Access Compliance Report

Public Rights-of-Way

| Intersection ID: 17570 | Main Street: RANDOLPH_RD | Cross Street: WOODLARK_LN | Location: W |
| ADA ID: AB19AE495C4B | Ramp Type: Perp | Initial Pass/Fail: Fail | Overall Compliance: No |

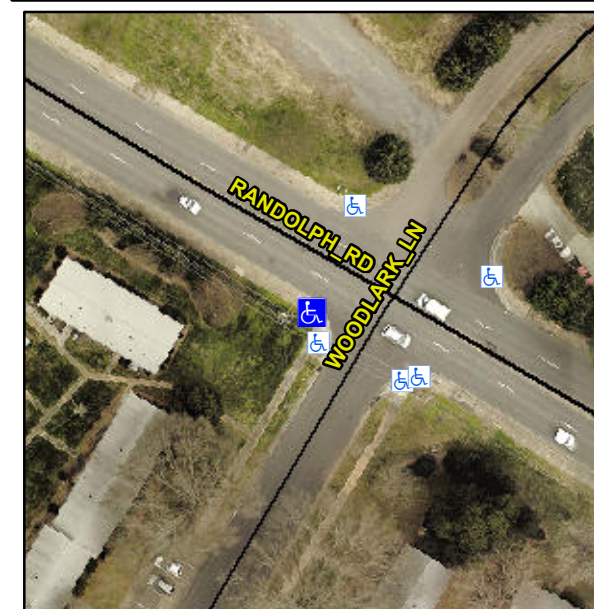
Not Found, R304.5.1

| Compliance | Description | Data | Compliance | Description | Data |
|------------|-----------------------|-------|------------|-----------------------------|------|
| No | Ramp Width (in) | 40.0 | Yes | Ramp XSlope (%) | 1.7 |

Remove & Replace Entire Ramp.
